**re: Casuarina Town Centre
Concept Approval and Project Application Approval 06_0258
Section 75W Modification No. 7**

We write with reference to your email of 16 January 2014 requesting additional information in relation to the above Modification 7. The Proponent has provided the following information in response to your request.

Title	Casuarina Shopping Centre Traffic Response		
Client	Consolidated Properties Group	Project No	CE008491
Date	4 February 2014	Status	Final
Author	Brett McClurg	Discipline	Traffic and Transport
Reviewer	Brett McClurg	Office	Brisbane

FIGURE No. DA122 (08/09/10)
PROPOSED ADDITIONAL WORKS IN LOT 10

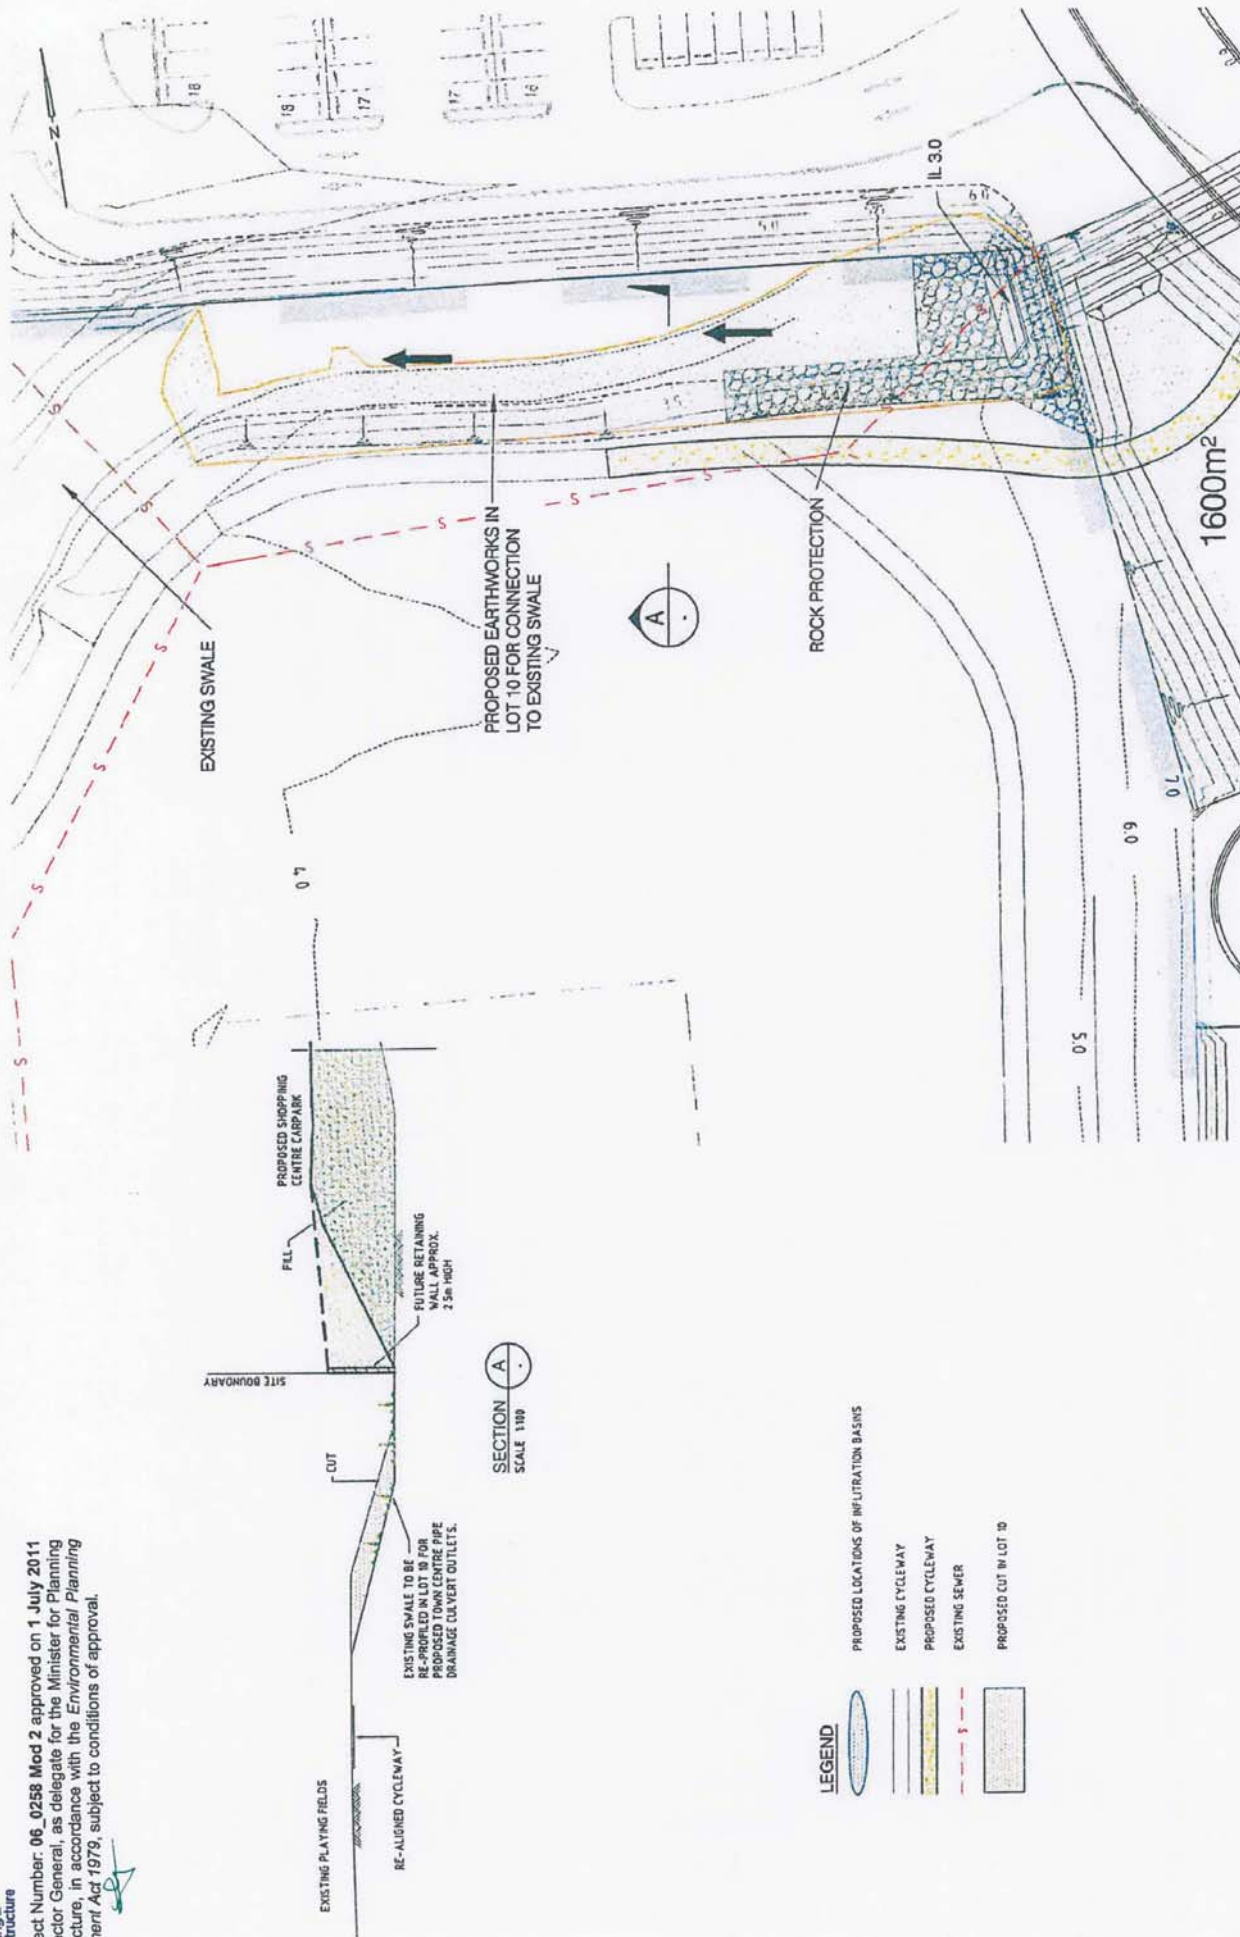
The Department has requested additional information on adjustments to the drainage swale resulting from this modification and any potential implications on the approved stormwater management regime. Cardno Eppell Olsen reviewed this request and provide the following response:

As shown in Section A of the attached Casuarina Town Centre Figure No. DA122 (08/09/2010), approved 1 July 2011 (Attachment 2), it is intended to partially realign the alignment and reconfigure the cross section profile of the swale bordering the southern boundary of the retail centre. The construction of the Stage 1 bulk earthworks for the overall Casuarina Town Centre site is currently underway. As noted in Section A, the compensatory earthworks will be undertaken on the southern side of the swale profile in order to maintain the flow capacity of the open channel downstream (i.e. west) of Casuarina Way.
